Access Compliance Report

Public Rights-of-Way (Curb Ramps)

Intersection ID: 18507	Main Street: BROOKRIDGE_LN	Cross Street: PROVIDENCE_RD	Location: S
ADA ID: B74D1B337431	Ramp Type: PerpDiag	Initial Pass/Fail: Fail	Overall Compliance: No
		Severity Score: 25

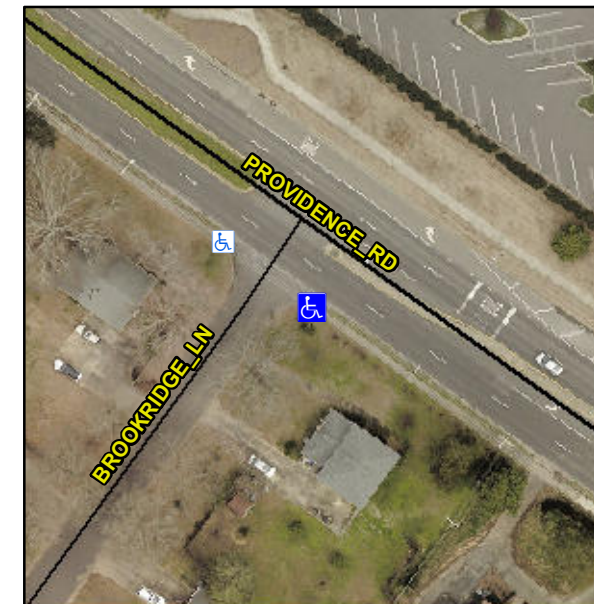
Not Found, R304.2.2

Compliance	Description	Data	Compliance	Description	Data
N/A	Ramp Length (in)	37.0	No	Ramp Slope (%)	12.8
Yes	Ramp Width (in)	48.0	Yes	Ramp XSlope (%)	1.8
N/A	Flare Type LT	N/A	N/A	Flare Type RT	N/A
N/A	Flare Slope LT (%)	N/A	N/A	Flare Slope RT (%)	N/A
N/A	Flare Traversable LT?	N/A	N/A	Flare Traversable RT?	N/A
N/A	Landing Length (in)	N/A	N/A	DWS Provided?	N/A
N/A	Landing Width (in)	N/A	N/A	DWS Contrast?	N/A
N/A	Landing Slope (%)	N/A	N/A	DWS Length (in)	N/A
N/A	Landing X Slope (%)	N/A	N/A	DWS Full Width?	N/A
N/A	Landing Curb? (Y/N)	N/A	N/A	DWS Offset (in)	N/A
N/A	Shared Landing?	N/A			
N/A	Gutter Ponding?	N/A	N/A	Gutter Slope (%)	N/A
N/A	Gutter Lip Ht (in)	N/A	N/A	Gutter X Slope (%)	N/A
N/A	Painted X Walk1?	No	N/A	Painted X Walk2?	No
	X Walk 1 Direction	To NE		X Walk 2 Direction	To NW
N/A	X Walk 1 Width (in)	N/A	N/A	X Walk 2 Width (in)	N/A
	X Walk 1 Slope (%)	4.3		X Walk 2 Slope (%)	2.5
	X Walk 1 X Slope (%)	1.2		X Walk 2 X Slope (%)	2.4

Remove & Replace Curb Ramp With Two New Directional Ramps or Equivalent.
